1982 - 1993 Corvette: Service Bulletin: Buzzing Noise at Idle

Subject: BUZZING NOISE AT IDLE (INSTALL PRESSURE REGULATOR VALVE)

Bulletin Number: 93-29-7A

Figure 1

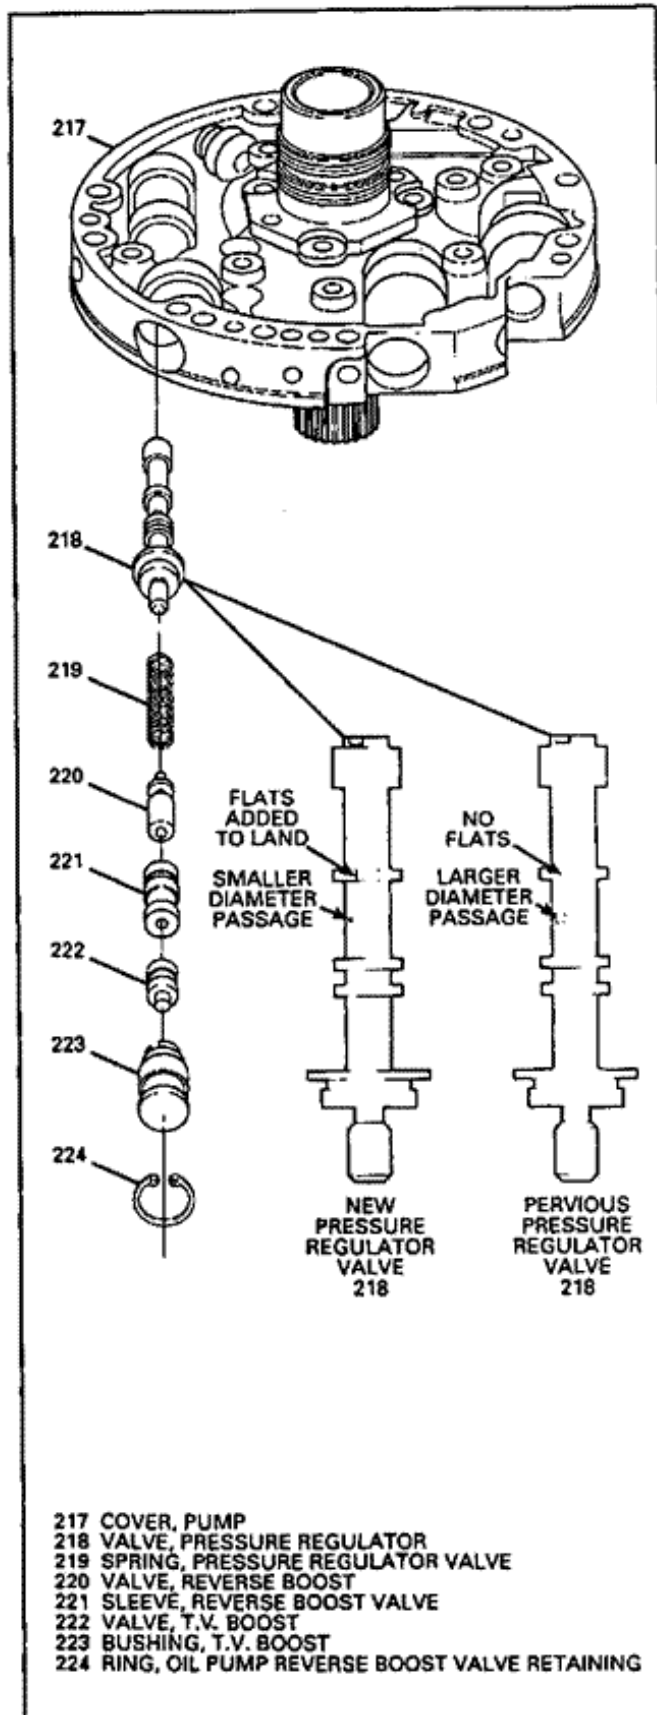
Some 1982-1993 vehicles equipped with a HYDRA-MATIC 4L60 transmission may have a buzzing noise coming from the transmission when the vehicle is at idle. The buzzing noise may be noticed more when the vehicle is in reverse at idle.

The buzzing noise may be a result of pressure regulator valve oscillating due to oil pressure instability at lower idle RPM.

A new pressure regulator valve (III. 218) has been made which will improve the oil pressure stability at lower RPM.

Valve, Pressure Regulator (III. 218) 8684048
